## SERVICE TECHNICAL INFORMATION

### ONE POINT REPAIR

UTSUNOMIYA, JUNE 15, 1996  
REF. NO. : SI-96-011  
CUSTOMER RELATIONS & SERVICE DIV.

MODEL : AM-F3  
SUBJECT : Occasional dropout (microcomputer upgrade)  
CONTENTS : Occasional dropout occurs (during play / record). Perform the following remedy for the relevant sets. Confirmation is very difficult because the symptom occurs in aluminum discs that can only play and in MO discs that play and record. For this reason, always perform this remedy when the customer indicates such a problem, even if the symptom does not occur.

Parts position

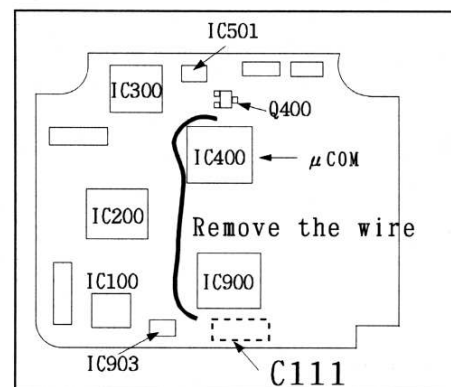
REMEDY : Replace Ref: IC400 with the new microcomputer (CXP81840-503). (Presently, 3 types of microcomputers are installed.)

- ① The previous microcomputer and the new type have upper compatibility. However, their circuit configurations are different and so the circuit modification shown below must be performed.

1. Remove one wire from the sets with CXP-81840-115.  
(See figure on the right.)
  2. Replace C111 0.1μF with resistor 1KΩ  
(C111 is on the bottom side of the board. Check with S/M for the positioning of the parts.)  
[ Part No.: Resistor 1KΩ 88-108-102-080 ]

3. For improved servo operations and to achieve compatibility, always perform the steps outlined in **Service Technical Information** "SI-96-006" after replacing the microcomputer.
